Letter of Transmittal

Project reference: Former Chrysler Kenosha Engine Plant
 Groundwater Remediation
 WDNR FID 230004500
 BRRTS #02-30-000327

Response to Comment Letter Dated September 23, 2019

PLAN VIEW - GROUNDWATER QUALITY EXCEEDANCES
KENOSHA ENGINE PLANT
CITY OF KENOSHA
KENOSHA, WISCONSIN

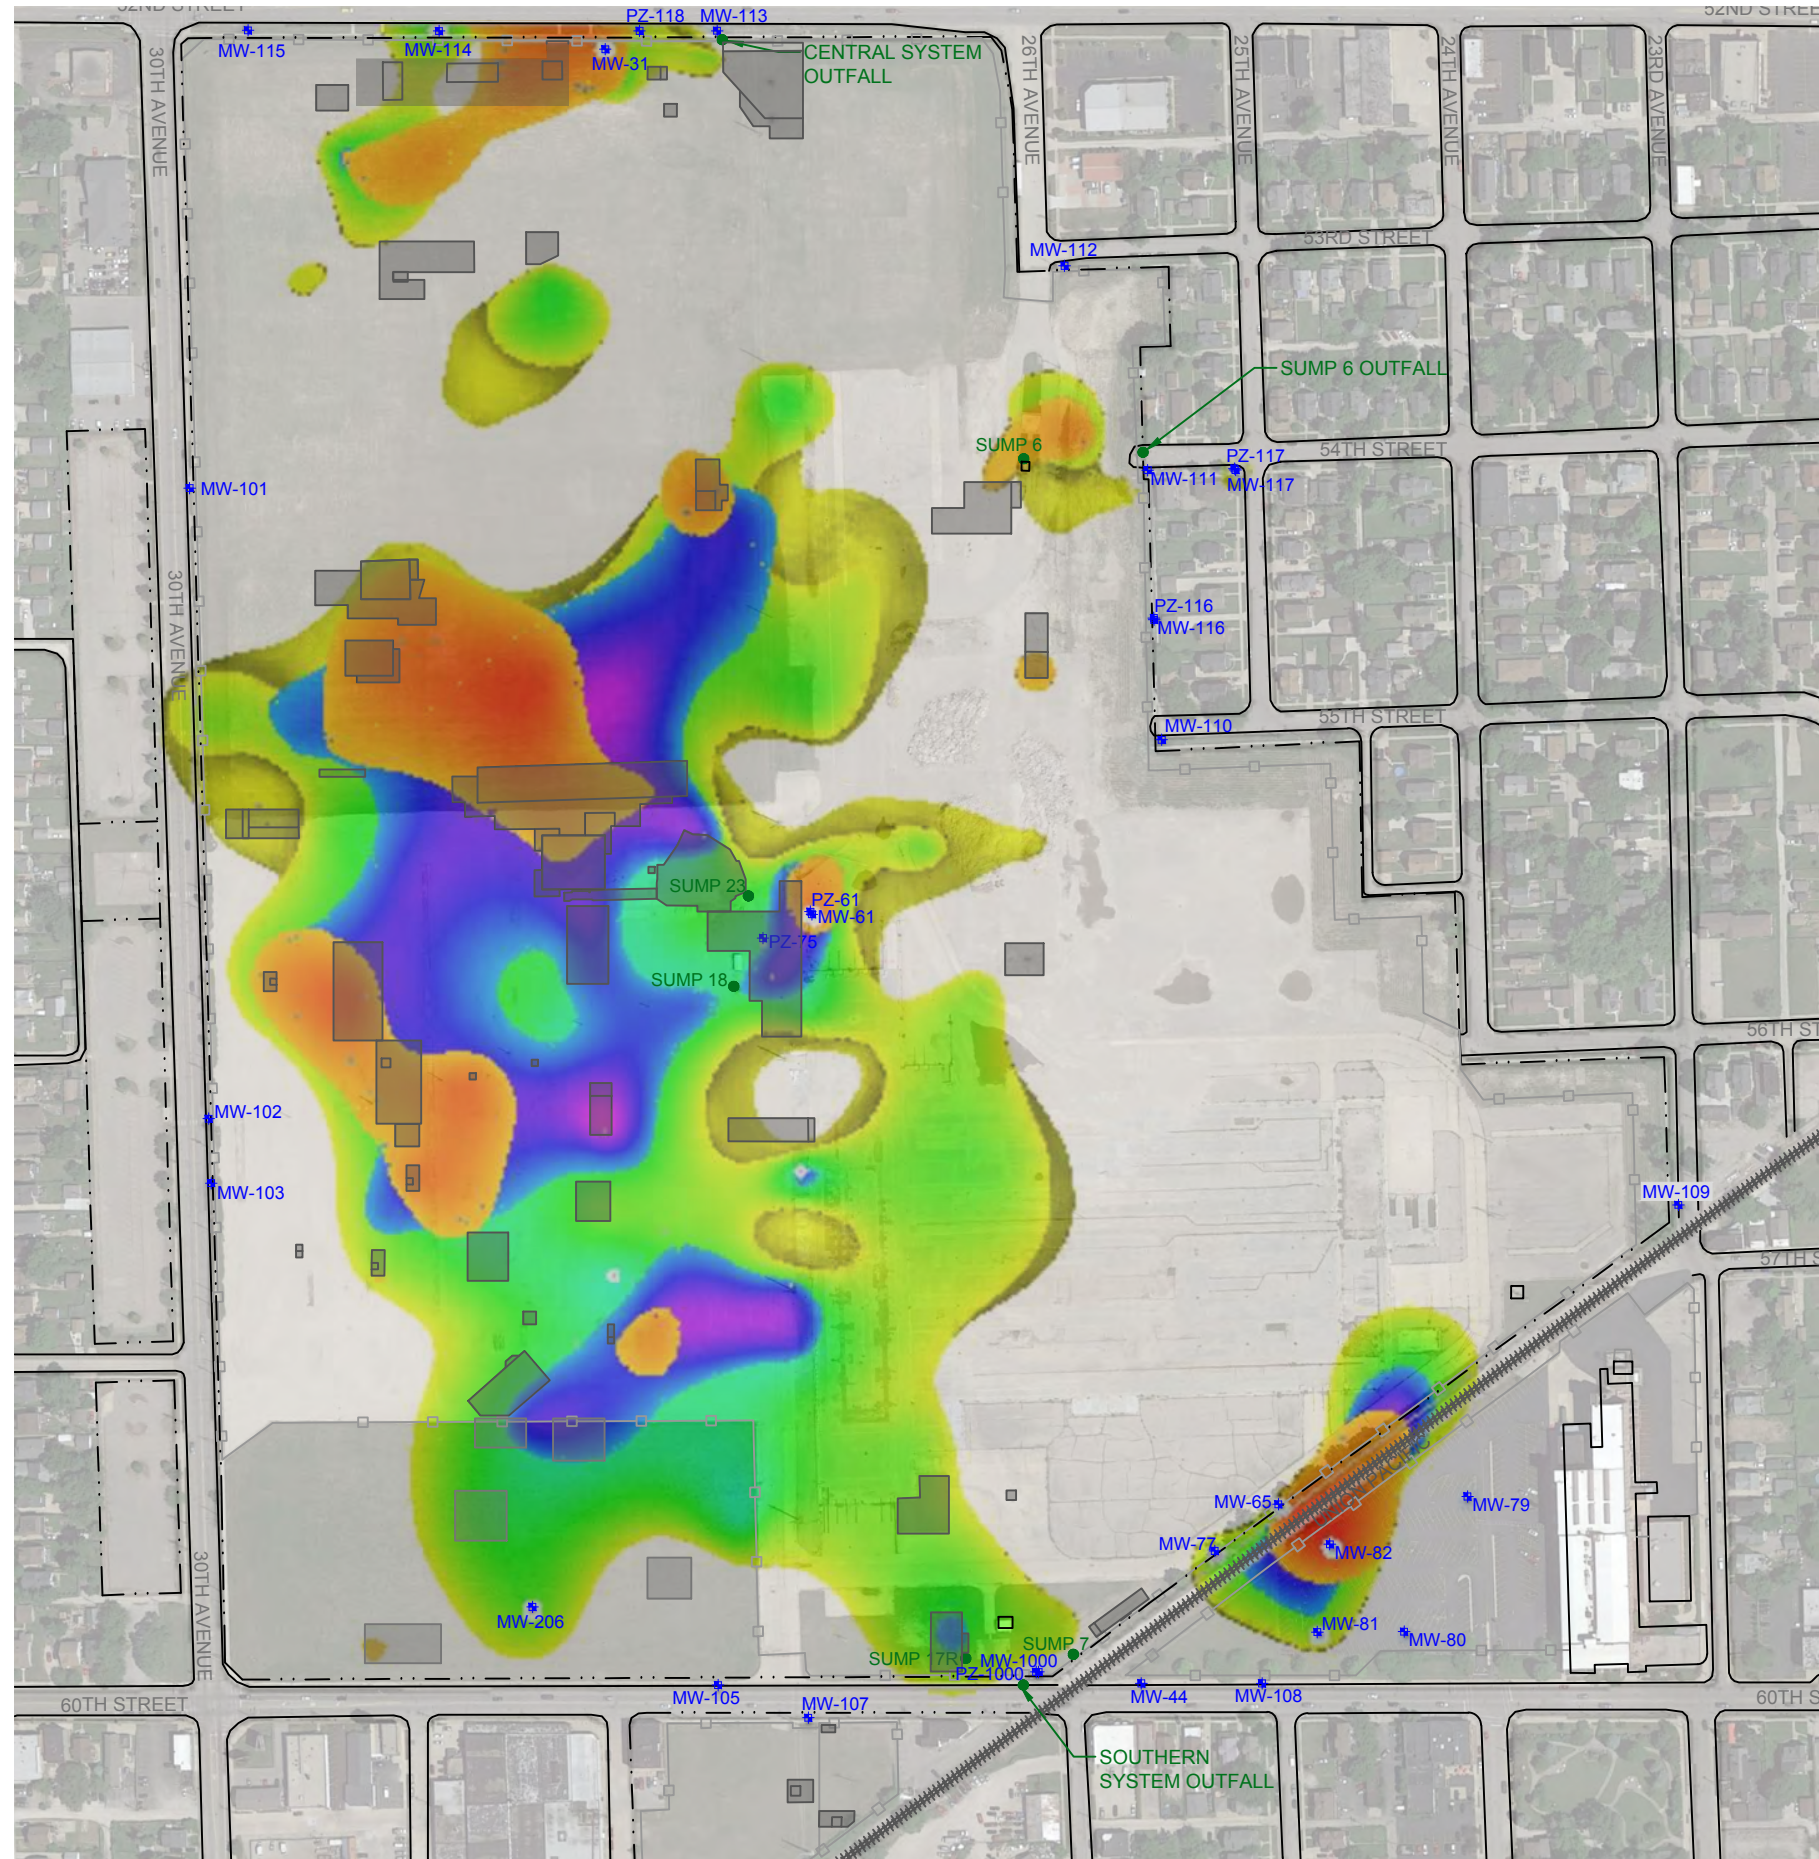
- 2) *The Report must explain how the groundwater contaminant plume limits depicted on the figures were generated and identify the data they are based on.*

The groundwater plume limits are based primarily on the 2015 NR 716 site investigation conducted by AECOM. As part of the 2015 site investigation more than 20 years of historical data

This discussion of the groundwater plumes and how Figures 8-10 were generated will be added to Section 2.3.2 in the Remedial Design Report.

CROSS SECTIONAL VIEW - GROUNDWATER QUALITY EXCEEDANCES
KENOSHA ENGINE PLANT
CITY OF KENOSHA
KENOSHA, WISCONSIN

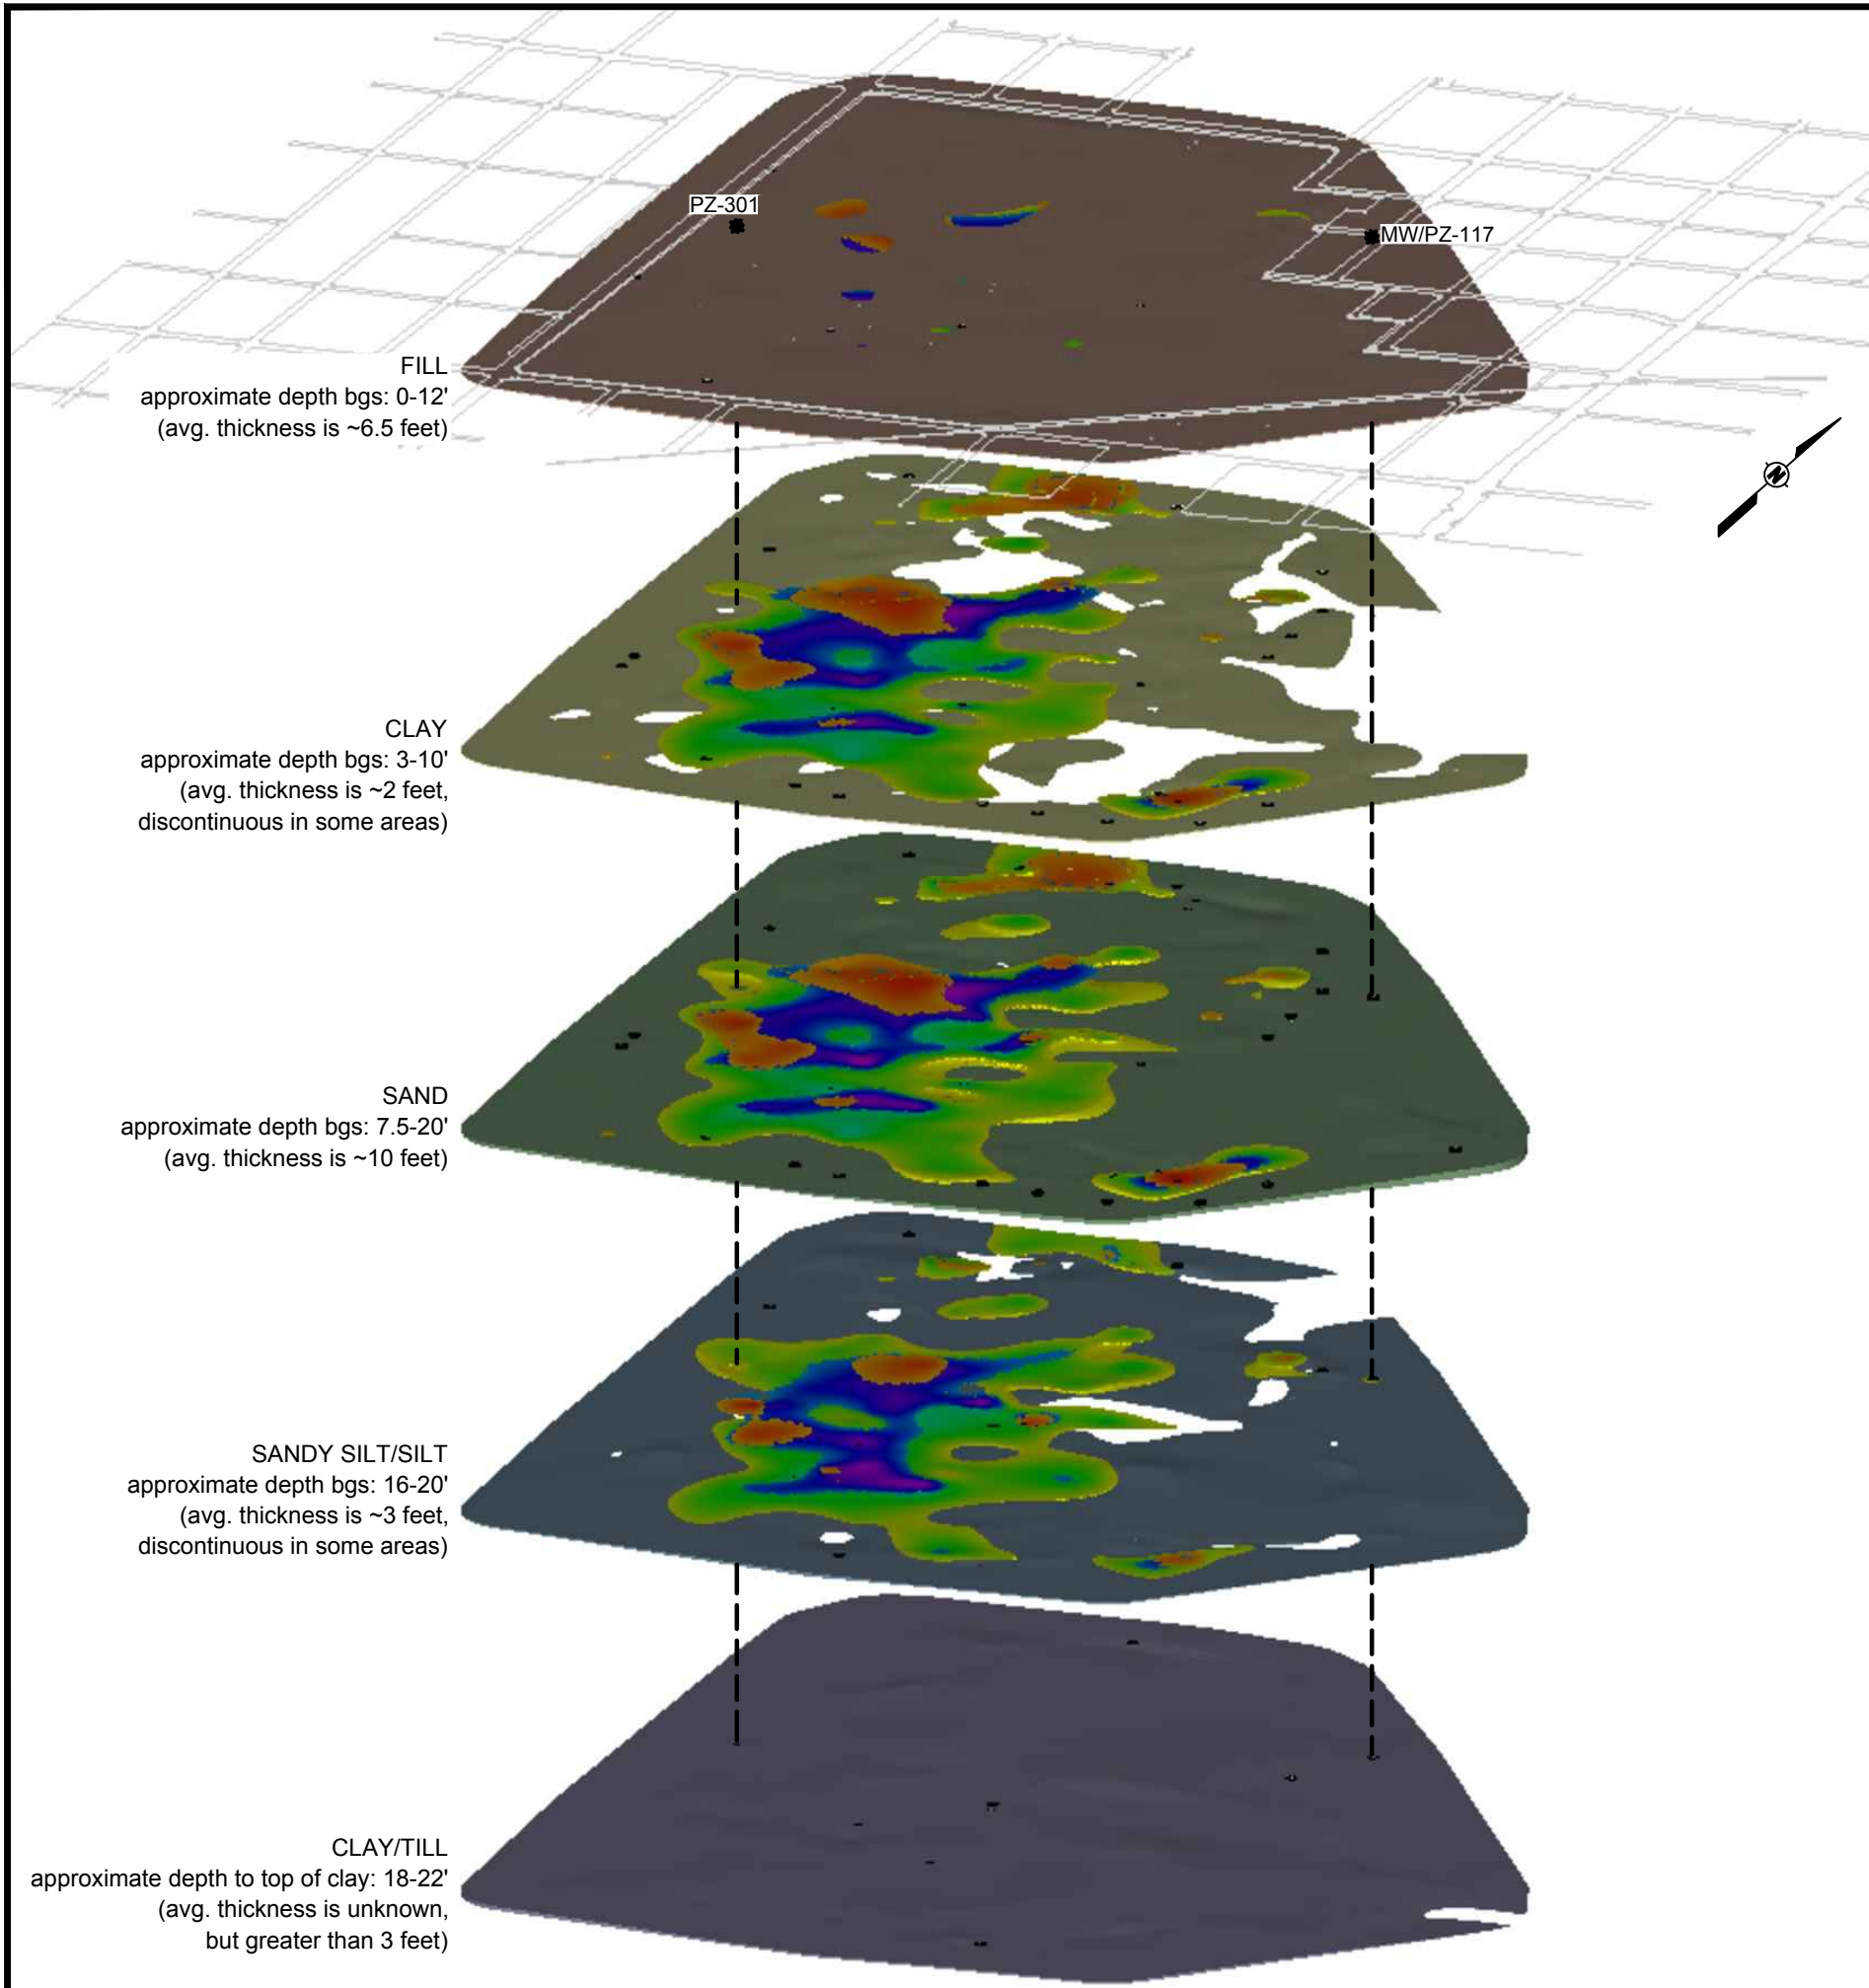
- 6) *The DNR requests that additional wells and piezometers be proposed to ensure that the monitoring network will define the limits of groundwater contamination and track plume behavior over time. The monitoring well and piezometer network should be expanded to encircle the groundwater plume limits of Area 1 depicted on Figure 10 of the Report. The monitoring well network must also ensure that all areas where groundwater contamination has been identified will be assessed during future sampling events. At a minimum, this would require that monitoring wells be installed within Area 2, Area 3, and areas of the site with groundwater contamination that exist outside of defined treatment Areas. The installation of additional piezometer(s) should be proposed in Area 4. Depicting the location of proposed monitoring wells and the location of piezometers on separate maps, in relation to the plume limits detected on the shallow or deeper portion of the aquifer, would be useful in demonstrating that the proposed network would be adequate to assess the groundwater plume.*

The lateral extents of the contaminant plumes depicted are for the full aquifer thickness and a 3-D representation – not a two-layer system, therefore, the concentrations of both the water table wells and the piezometers (which represent concentrations at the base of the shallow aquifer) were used to depict the plume in three-dimensional space. Figure 9 is a cross-sectional view of the three-dimensional representation of the groundwater plume. The first layer at the top is the unsaturated soil from zero to 12 feet below ground surface. The first layer shows areas of the surface where contaminants were not excavated because their concentrations were below threshold values chosen prior to soil remediation. The second layer depicts clay below the fill, its thickness varies from three to 10 feet thick, with an average thickness of two feet. The third layer is sand that has an average thickness of 10 feet. The fourth layer is a sandy silt, where some of the higher concentrations of TCE were observed in soil samples. The bottom layer is the top of the clay till, a lateral extensive unit found across much of the City. VOCs were not detected in soil samples taken from the till found at 19 to 25 feet bgs.

The sandy silt layer depicted on Figure 9 is the best depiction of the contaminant plume at depth. When compared to the plume boundaries in the two layers above the sandy silt, the extents are very similar. Thus, the depicted monitoring wells and piezometers as shown on Figure 10A provide coverage for the contaminant plume at the water table and at the bottom of the shallow aquifer.
